CABINET MEMBER FOR ENVIRONMENT– 13 OCTOBER 2016

PROPOSED PUFFIN CROSSING – CUMNOR HILL, CUMNOR

Report by Deputy Director for Environment & Economy (Commercial)

Drawing title
**PUFFIN CROSSING
 PROPOSED LOCATION
 ANNEX 2**

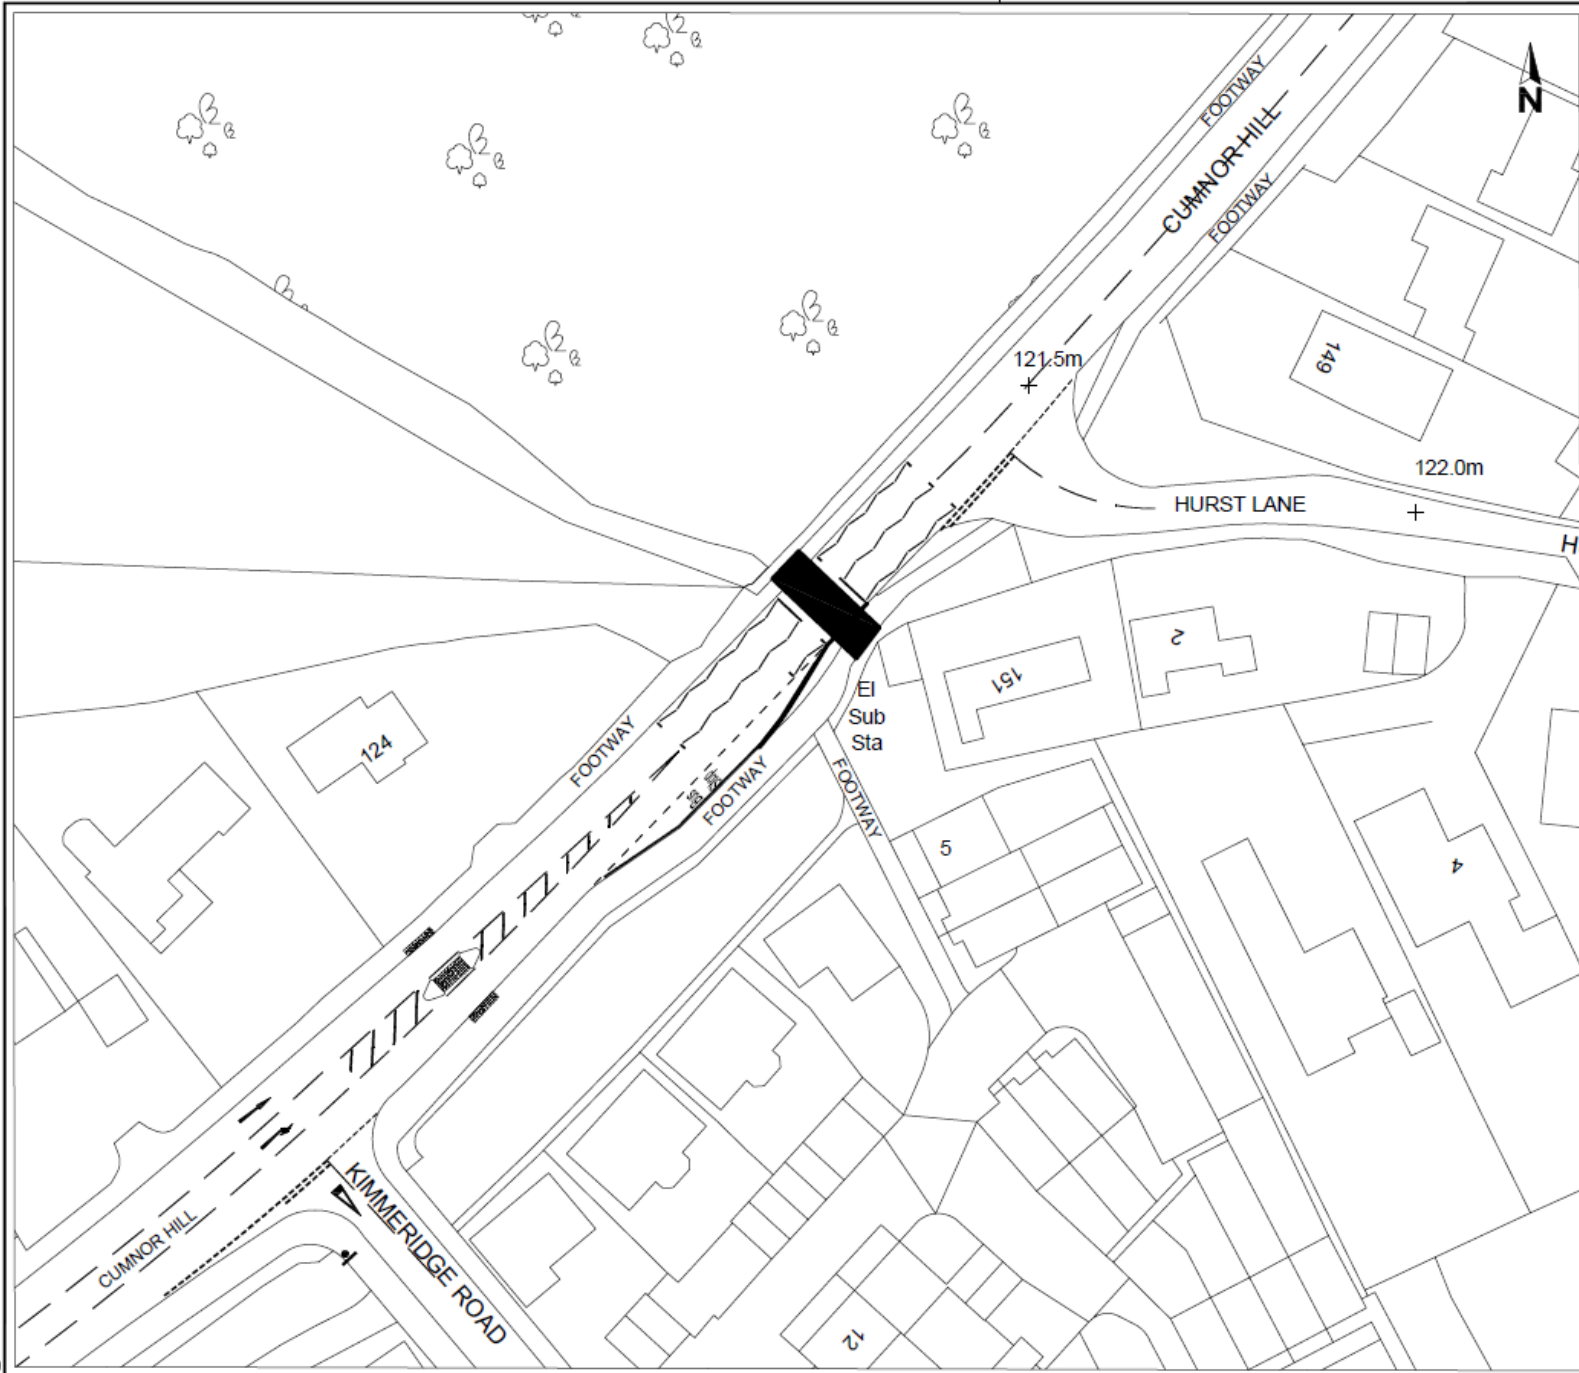
6. The main issue raised by those objecting to the proposed crossing concerned its location, with most feeling that it should be further west of the proposed site. In response, it is accepted that at present there are a variety of places where pedestrians cross Cumnor Hill but the conclusion drawn from the survey undertaken by the Parish Council recommended the proposed location and indicated that this is where the majority of pedestrians cross in the vicinity of the new development (which is funding the crossing).

7. Another main concern raised was the narrowness of the northern footway near the proposed crossing location. It is acknowledged that this is currently heavily overgrown and the verge has encroached onto the footway; both these issues will be addressed during construction of the crossing which will then mean a footway of adequate width is provided.

8. The owner of the land to the north of the proposed crossing objects as it is immediately adjacent to an existing vehicular entrance into the field behind. The landowner believes the presence of the crossing would cause obstruction to large agricultural vehicles entering or leaving and a danger to pedestrians using the crossing. In response, officers met the objector on site to discuss his concerns. Computer modelling has been undertaken of the movement of all likely vehicles to use this access and the results (which show the crossing would have no adverse effect on the access) have been passed to the landowner.

9. Other concerns raised relate to the closeness of the proposed crossing to Hurst Lane and the existing bus stop, and the noise arising from the audible beepers. These are matters of detail which can be addressed following safety audits of the final design.

10. Finally, some respondents sought the removal of the existing pedestrian refuge located west of the site of the proposed puffin crossing. Whilst its removal might encourage more use of the new crossing, its retention would continue to have a calming effect on traffic (by narrowing the road) and also protect vehicles waiting to turn right into Kimmeridge Road. It is therefore proposed to retain the refuge at least initially and to keep its presence under review.

13. **The Cabinet Member for the Environment is RECOMMENDED to approve the implementation of proposal as advertised and described in the report.**

Drawing title
 PUFFIN CROSSING
 PROPOSED LOCATION
ANNEX 3

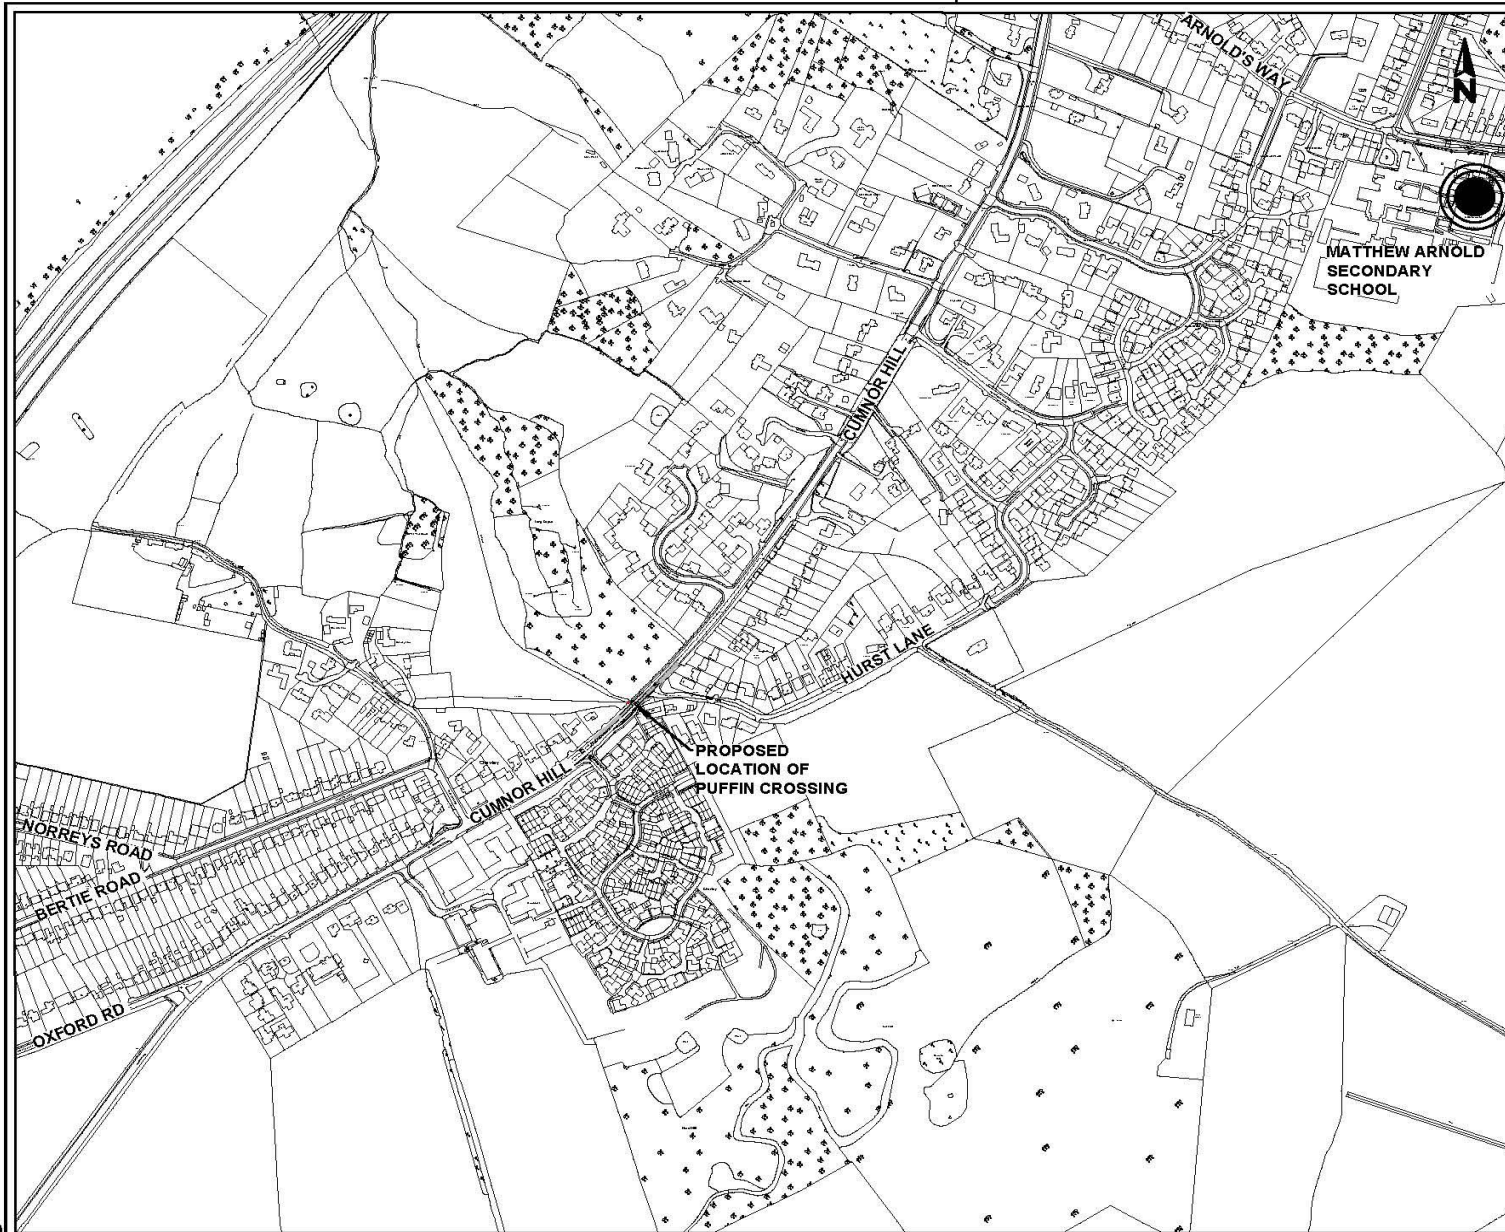
RESPONDENT	SUMMARISED COMMENTS
Thames Valley Police	<p>No objection providing this layout meets the approved standards</p> <p>The following issues have been raised:</p> <ul style="list-style-type: none"> • The footway on the north side is extremely overgrown and reduced in width by overhanging foliage. This foliage also seriously restricts visibility of traffic from the westbound direction and considerable cut back is essential. • Whilst on site, saw no desire to cross at this point (there is an existing crossing point further west towards Kimmeridge Road) and enquires whether as part of the proposal that crossing point will remain or be removed. Leaving it in situ may discourage use of the new formal crossing point.
Cumnor Parish Council	Ask that the existing central reservation be removed prior to the puffin crossing being installed.
Resident on the Cumnor Development	Respondent suggests that the crossing could be better placed, i.e. nearer to the car garages i.e. past the development if coming up from Botley.

No address given	<p>Respondent objected for the following issues:</p> <ul style="list-style-type: none"> • Crossing will only be used at peak times, if at all. • In completely wrong position for large housing development • Noise pollution from beeping crossing and vehicles accelerating/deceleration

<ul style="list-style-type: none"> • Too close to junction of Hurst Lane, creates bind spot • Right next to a grade 2-listed cottage C16, will adversely affect value and heritage (English Heritage have been consulted) • Right next to electricity sub-station, not a great idea as it will mean gatherings of youths presenting obvious danger to life • Crossing better placed further west
No address given	The point at which the crossing is proposed is a very narrow point and the footway on the opposite side to Hurst Lane is particularly narrow, making it a less suitable crossing point than the islands further up the Hill nearer to Kimmeridge Rd after the bus stop. More pedestrians are likely to use the point here.
No address given	Respondent believes the crossing is in the wrong place and will not pick up children at it's proposed location.
Resident on Cumnor Hill	<p>The owner of the land to the north of the above proposal strongly objects to the location of the Puffin Crossing as this is immediately adjacent to an existing vehicular entrance into the field behind. It would cause obstruction to large agricultural vehicles entering or leaving and a danger to pedestrians using the crossing.</p> <p>Respondent suggests that more suitable location of the crossing for those aiming for the village and the school be Kimmeridge Road using the existing island crossing upgraded to a "Puffin", which has wider footpaths than the proposed one which are only one metre deep.</p>

No address given	<p>Respondent raises the following concerns after speaking to some residents who use the busses regularly:</p> <ul style="list-style-type: none"> • There is a pedestrian crossing on the proposed location, it would be more advantageous to put the puffin crossing on Chawley Lane opposite the Jaguar garage further up Cumnor hill where most school children and families get off to access the Cumnor Ridge estate. • As cars are coming off the carriageway they are coming down quite fast until they slow down much further down Cumnor hill road.

Resident on Cumnor Hill	Respondent raises the following issues: <ul style="list-style-type: none">• The current site lies too far down the Hill to be of use to most parents walking their children to school.• At its proposed site, the crossing would take people to an old, narrow pavement which in many places is overgrown and which often has cars parked half on the pavement outside the houses and also has a number of driveways to negotiate.• Proposed site is very close to the existing bus stop. Visibility around the crossing will necessary be reduced when there is a bus on the stand.
Resident on Cumnor Hill	Respondent raises the following concerns over its location. <ul style="list-style-type: none">• Crossing sited in the wrong location• Proposed crossing location is too close to Hurst Lane and the bus stop
Resident from Kimmeridge Road	In full support of the planned puffin crossing.
